# Public Meeting to Discuss NRC Comments on Responses to RAI Set 505, Question 7.1-36, 39, and 44

Duc Phan, Chris Doyel  
Rockville, Maryland  
November 15, 2012

Excerpt from U.S. EPR FSAR, Tier 2, Figure 7.1-7

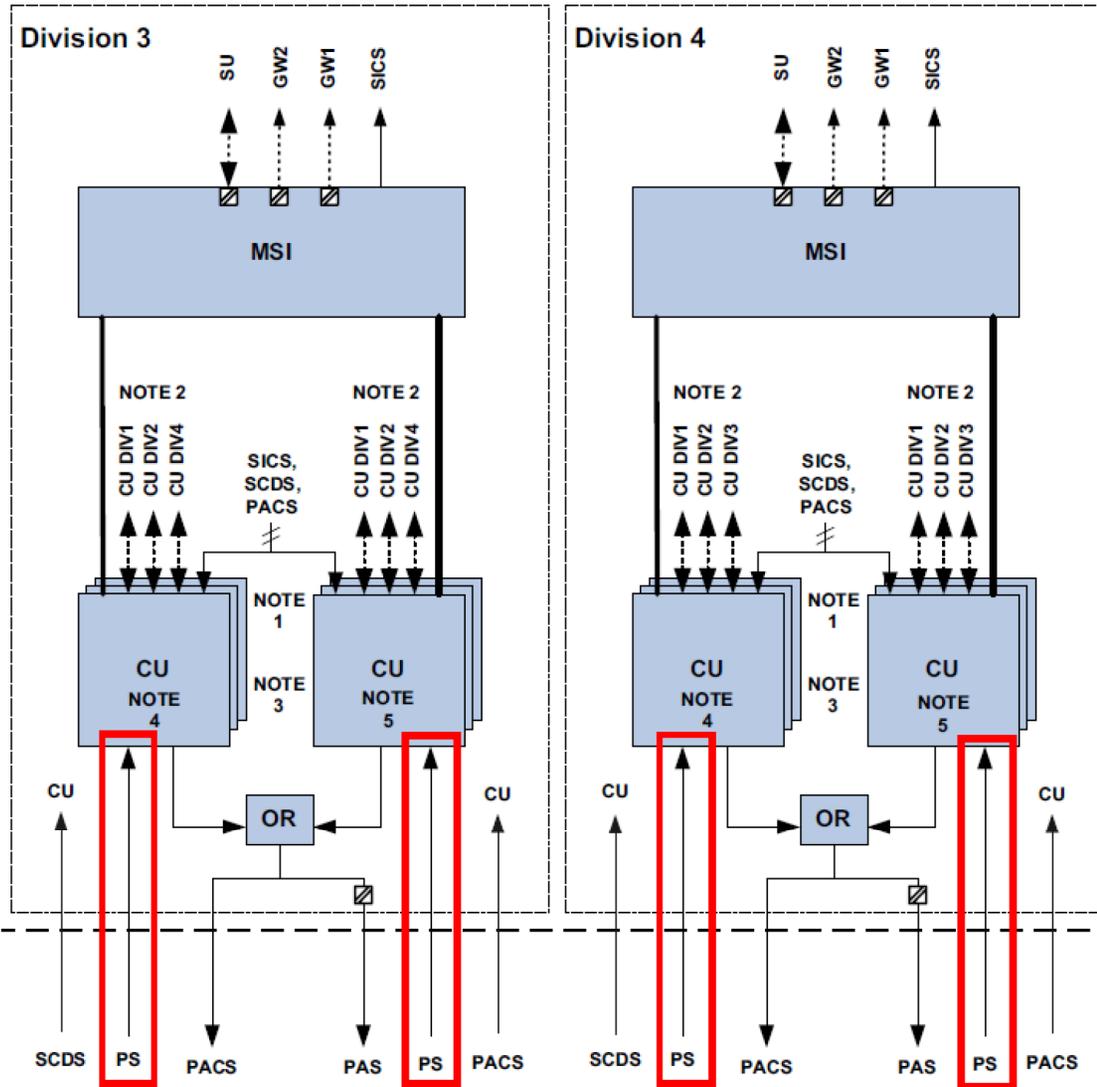
- ◆ 1. For Figure 7.1-7 [*shown on slide 4*], for each CU in which the PS feeds into the CU, what type of connection does this line denote? It doesn't appear to be a hardwired connection nor a networked connection based strictly on the drawing legend on the side of this figure.
  - The connections from the PS to the SAS are hardwired connections. This is shown in U.S. EPR FSAR, Tier 2, Figure 7.1-7 and denoted in the drawing legend.

◆ **2. Regarding Note 2 on Figure 7.1-7 [shown on slide 4]: Besides voting and system interlocks, what other functions require interdivisional communication?**

- ◆ **4. Regarding Figure 7.1-7 [shown on slide 4]: Clarify the relationship between SAS and PAS due to the figure showing an output from SAS to PAS. According to Table 7.1-4, the connection between SAS and PAS is a hardwired connection to, “Provide for coordination of logic between SAS and PAS (if needed).”**
  - The connection from SAS to PAS is a one way hardwired and isolated connection (shown on U.S. EPR FSAR, Tier 2, Figure 7.1-7) to send SAS information to PAS. Some functions of PAS may require inputs from SAS to execute its functionality (e.g. CCWS Emergency Leak Detection Function sends signal to disable CCWS Normal Operation Switchover if you have a leak). A description will be added to U.S. EPR FSAR, Tier 2, Section 7.1 to add clarification on the SAS to PAS connection.

- Engineered Safety Features (ESF) Control, Essential Auxiliary Support (EAS) Control, and Interlock functions are performed by SAS. Interdivisional communication is provided when required, for voting across divisions or due to the divisional power allocation to the mechanical and electrical portions of the system. U.S. EPR FSAR Tier 2, Table 7.1-5 lists all SAS functions and explains why interdivisional communication is required for selected functions (“Interdivisional Communications” column).

## Excerpt of U.S. EPR FSAR, Tier 2, Figure 7.1-29

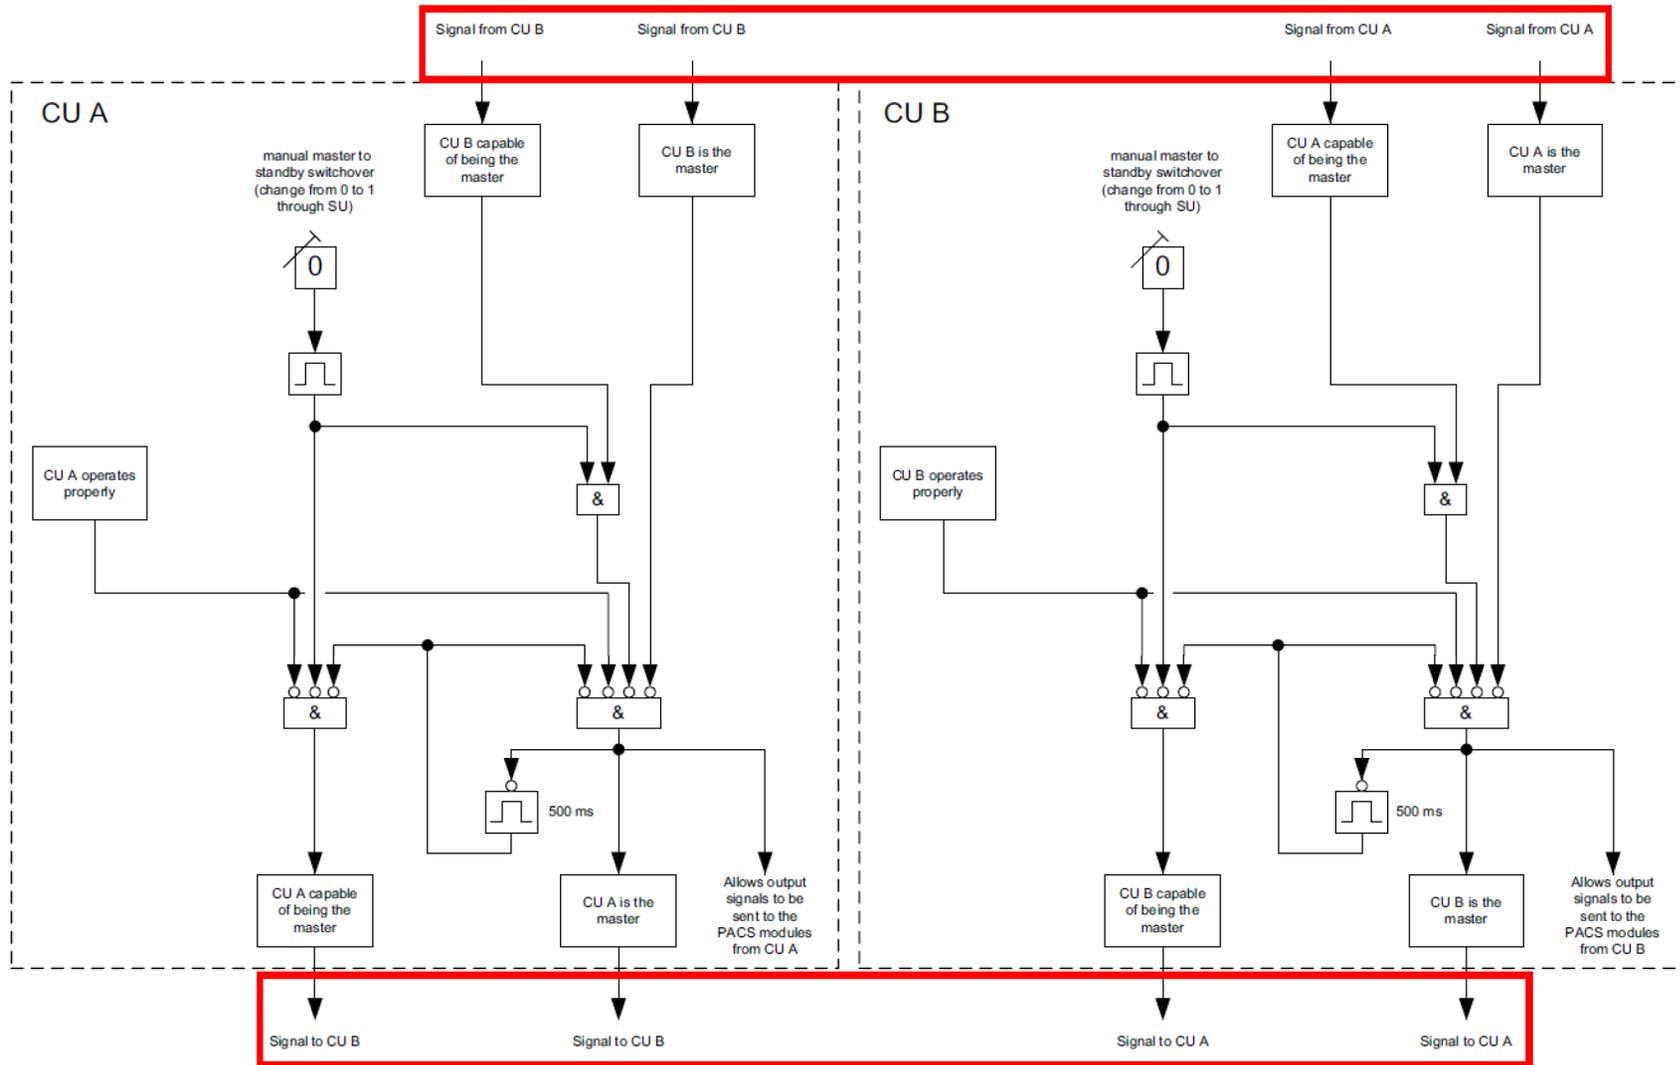
- ◆ **3. Regarding Figure 7.1-29 (Master/Standby Logic) [shown on slide 7] and 7.1-7(SAS Architecture) and Note 3 [shown on slide 4]: Where are the hardwired connections mentioned in Note 3 represented on Figure 7.1-29? All connections on the logic appear to be networked. Note 3 states that redundant CU pairs communication through hardwired connections. Also, what type of communication is conferred over the hardwired connection?**

- ◆ **5. Regarding Figure 7.1-29 [shown on slide 7], explain the significance of 500ms delay time. Is there a technical basis for this amount of time?**
  - There is no significance to the exact value of the 500ms. The 500ms prevents a CU from switching between master and hot standby within a short period of time. This ensures that both CUs have ample time to switch over to master or hot standby before having the ability to switch again. This amount of time was based on engineering judgment and experience from the European designs.

- Note 3 of U.S. EPR FSAR, Tier 2, Figure 7.1-7 states, “Redundant CU pairs communicate with one another through hardwired connections for master/hot standby switchover (connection not shown).” The connections between the CUs on U.S. EPR FSAR, Tier 2, Figure 7.1-29 are hardwired. Discrete (e.g. ON/OFF or 1/0) values are passed between the master and hot standby CUs through hardwired connections. U.S. EPR FSAR, Tier 2, Figure 7.1-29 is meant to show the master/hot standby switchover logic and not the hardware design.

# Excerpt from ANP-10315P, Figure A-1

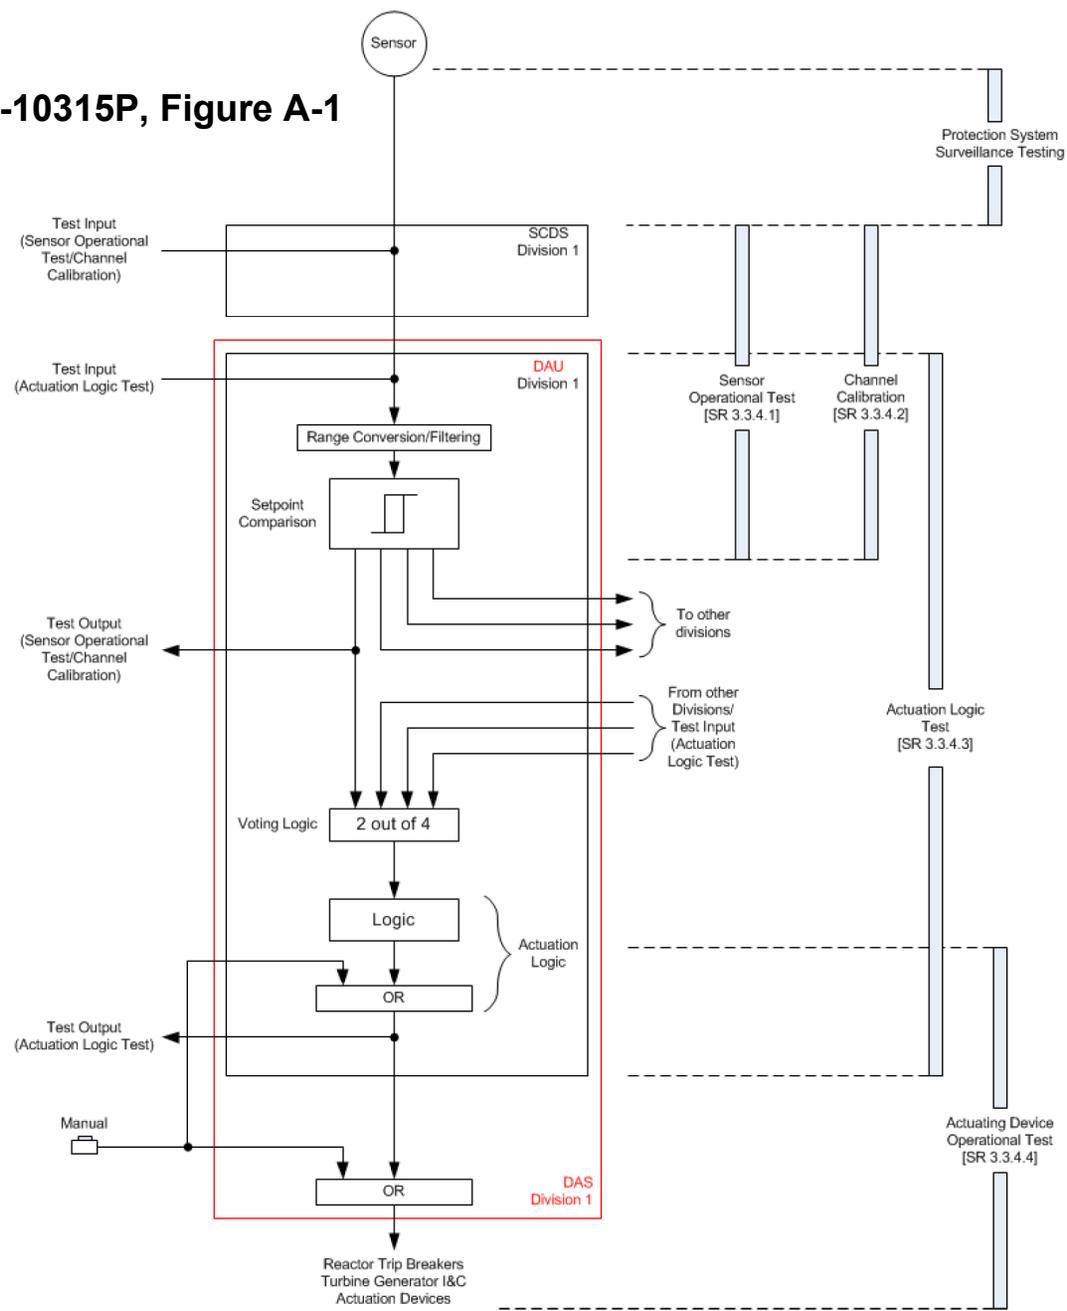
- ◆ 1. For Figure A-1 [*shown on slide 17*], refer to the OR gate at bottom of figure. Does this device exist outside or inside DAS logic? Does the Manual signal go to this or gate or does it actually run through the DAS logic?
  - The OR gate at the bottom of ANP-10315P, Figure A-1 is included as a part of DAS. The manual signal goes through both the DAS logic (inside the DAU) and this OR gate outside of the Diverse Actuation Unit (DAU). This figure and U.S. EPR FSAR Tier 2, Figure 7.1-13 will be revised to include the OR gate within the DAS system boundary.
